In relation to your request for an extension to provide further information for DA 202139248 at Blocks 13 & 22 Section 22 Kingston.

From: [Billing, Dale](#)
To: purdons@purdon.com.au
Cc: [Varlow, Trent](#); [Richard Davies \(Richard.Davies@act.gov.au\)](mailto:Richard.Davies@act.gov.au)
Subject: DA202139248 Blocks 13 & 22 Section 22 Kingston – Further information request
Date: 17 February 2022 21:18:00
Attachments: [DA202139248 Blocks 13.docx](#)

RESPONSE TO FURTHER INFORMATION REQUEST ON DA 202139248 (B13 & 22 S22 KINGSTON)

Description - PROPOSAL FOR A NEW COMMERCIAL DEVELOPMENT - Demolition of the existing buildings, pavements and structures and construction of a new four-storey commercial building with two level basement carparking, 5 surface carparking spaces, landscaping, removal of one verge crossing from Giles Street and modified vehicle access to the Laneway to the south of Block 22 and associated works.

FOR A DETAILED 15 MINUTE HOURLY ASSESSMENT BETWEEN 2pm AND 3pm REFER TO DRAWING A402

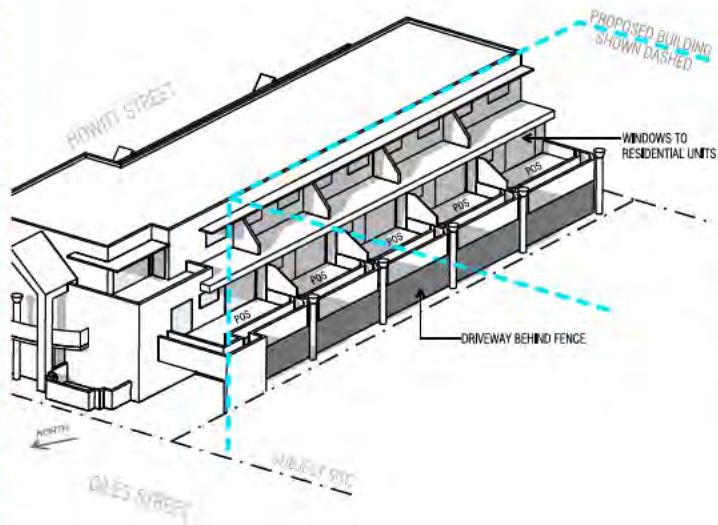
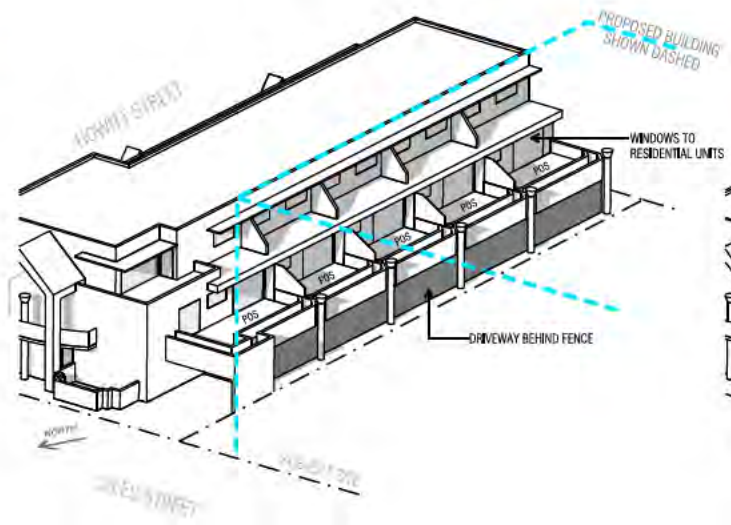
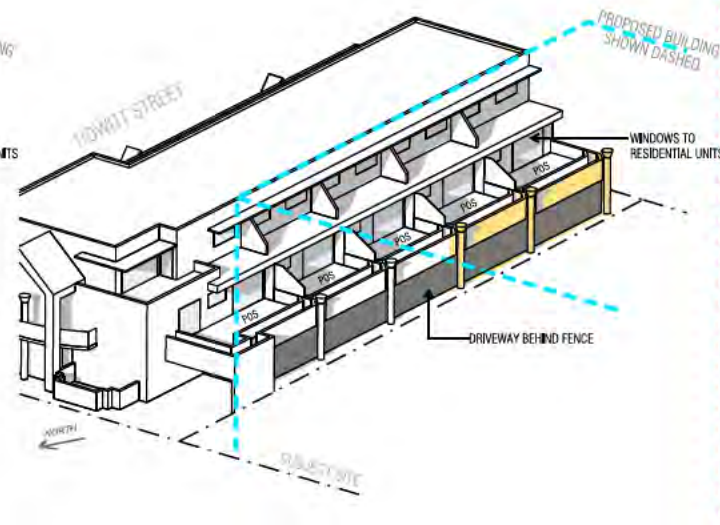
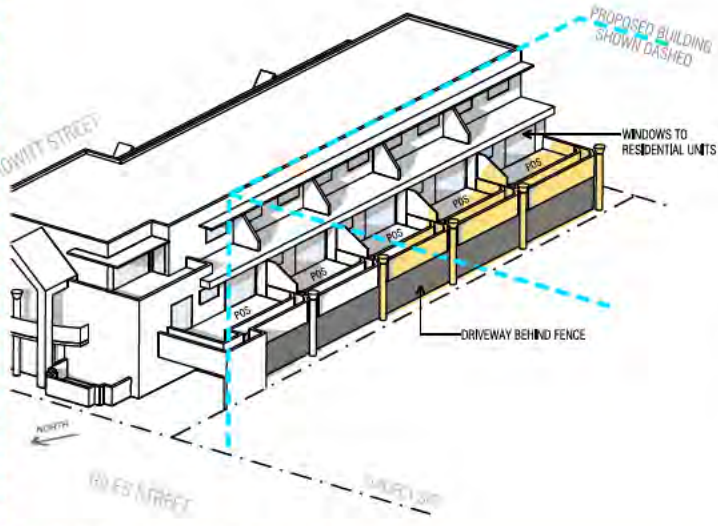
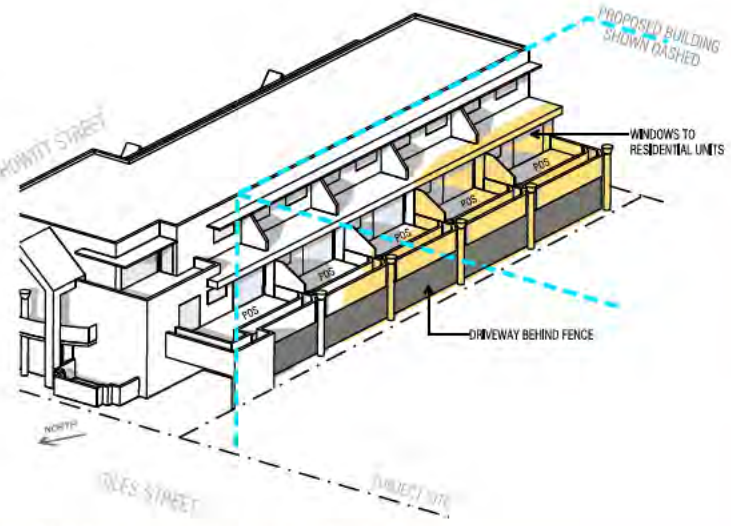
Issue	Response
<p>Also see comments regarding CZDC GFA limits for office at R43.</p>	<p>Please refer to the response provided at R43 below.</p>
<p>R20/C20 – The shadow diagrams and solar access plans submitted with the proposal to demonstrate compliance with this requirement do not clearly indicate additional overshadowing to the PPOS of residential buildings to the south of the Holford elevations provided (Blocks 19 & 20). It is noted that the living rooms are indicated to be orientated to the east however rear courtyards that provide PPOS are being overshadowed in the afternoon require further clarification and justification. A reduction in the overall height and UFL floor plates with an increase in the setback to the rear lane may need to be considered to reduce the overshadowing impacts to residential PPOS.</p>	<p>It is noted the buildings on Blocks 19 and 20 are located to the South-East of the proposal, not the South.</p> <p>Additional shadow studies have been undertaken to show the shadowing impacts on the rear areas of Blocks 19 & 20 (which being off the rear bedrooms of these dwellings, would not be considered Principal Private Open Space).</p> <p>These diagrams show significant overshadowing already existing from the design of the buildings on Blocks 19&20, and that additional overshadowing occurs from 12 midday on the winter solstice.</p> <p>The Shadow studies provided for Block 14 have also been updated following community commentary about accuracy of what is shown in the diagram.</p> <p>It is considered the additional information provided shows the proposed building retains a similar response as provided for in the submitted Statement Against Criteria but shows the effect of the shadowing in greater detail to allow for a thorough assessment of the proposal's response to the criteria.</p> <p>Design changes were considered in response to the wider RFI, such as removal of office floor space from Block 22 at the upper levels. However, removal of this showed very little change in the overshadowing effects of the proposal given the existing orientation and siting of the adjacent buildings, so were not pursued further.</p>

THE PROPOSED DEVELOPMENT DOES NOT CAST SHADOWS ON THE EXISTING DEVELOPMENT ON BLOCK 14 SECTION 22 KINGSTON UNTIL AFTER 2:30pm ON JUNE 21

A GRADE OFFICE ACCOMMODATION FLOOR TO FLOOR HEIGHT ANALYSIS

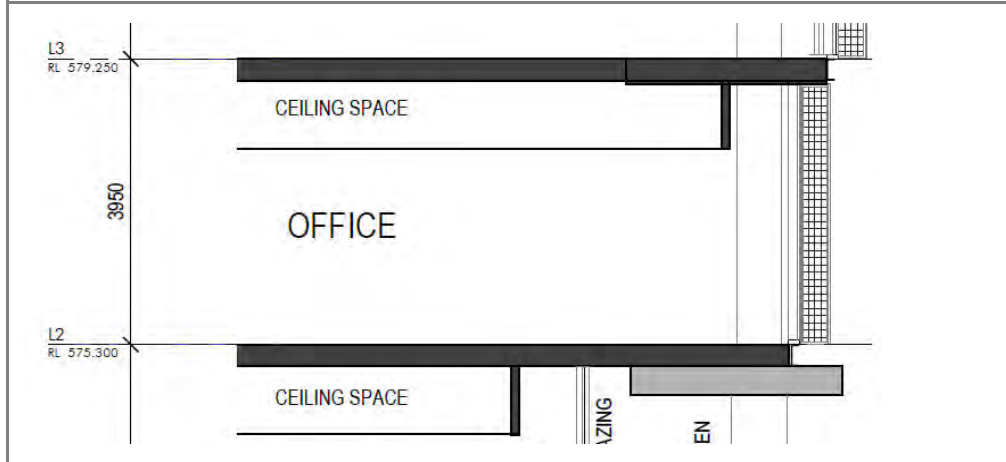
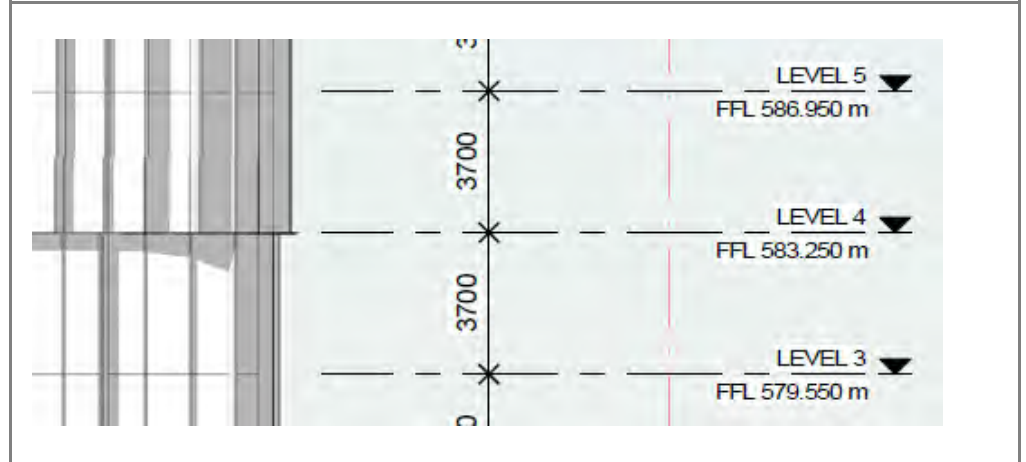
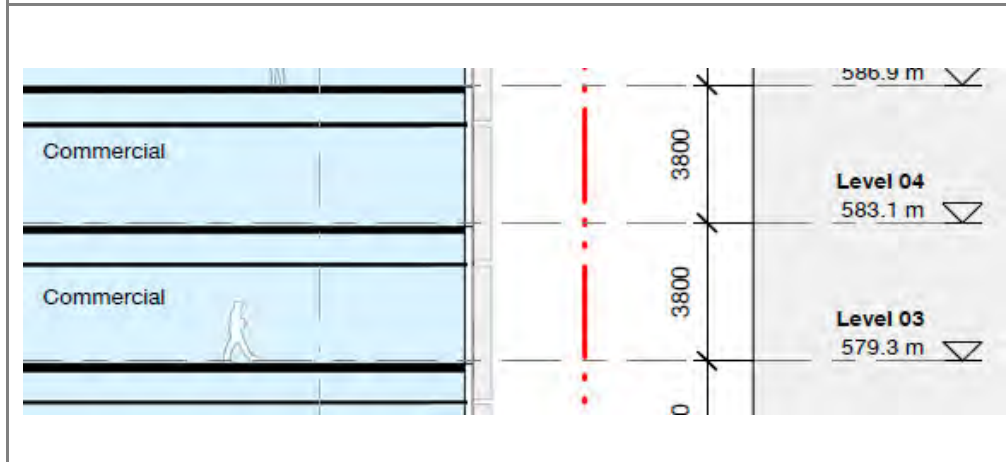
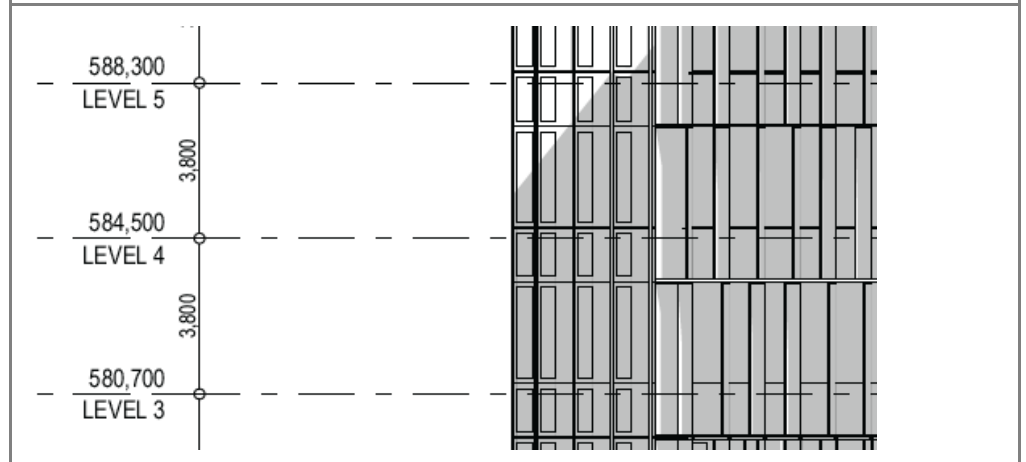
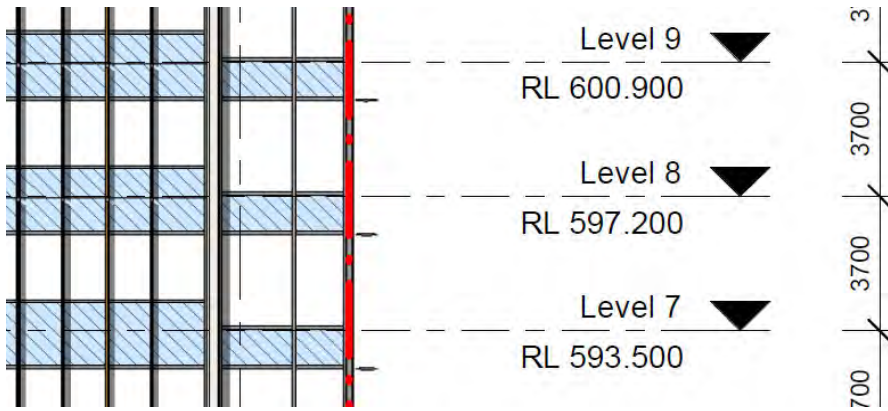
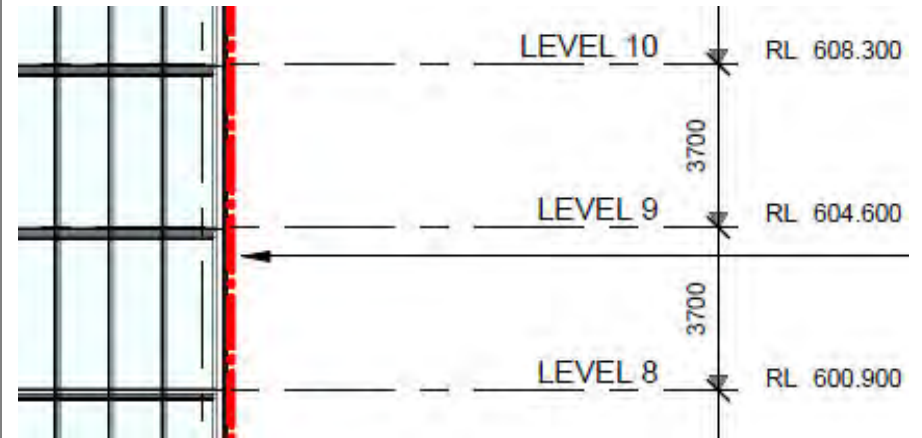
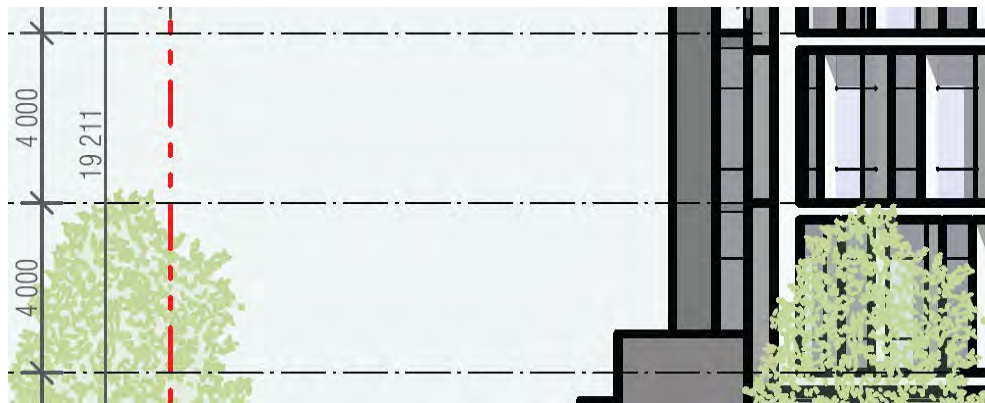
<p>C18 - See comments regarding overshadowing to building to the south at rule 22 below. A reduction in height through Floor to ceiling height changes as well as slab thicknesses should be considered to reduce the impact of overshadowing and reduce the overall scale of the building.</p>	<p>It is noted that the floor-to-floor heights of this proposal are greater than what would be designed, had it been designed for residential purposes. However, due to the use of the space as A-Grade office, the heights provided are as low as is possible to provide the servicing and design requirements for the use.</p> <p>For comparison, Turco & Associates have prepared an analysis of high-quality office spaces around Canberra. This comparison demonstrates the heights proposed with this application are at the minimum provided across the Territory for A-Grade office spaces, which are in short supply across Kingston.</p> <p>As a result, no reductions in the floor-to-floor heights are considered appropriate.</p> <p>Please refer to the overshadowing response at C20 response below.</p>

Floor to floor levels shown allow for a minimum of 2.7m ceilings along with the required mechanical, hydraulic, fire and electrical services required
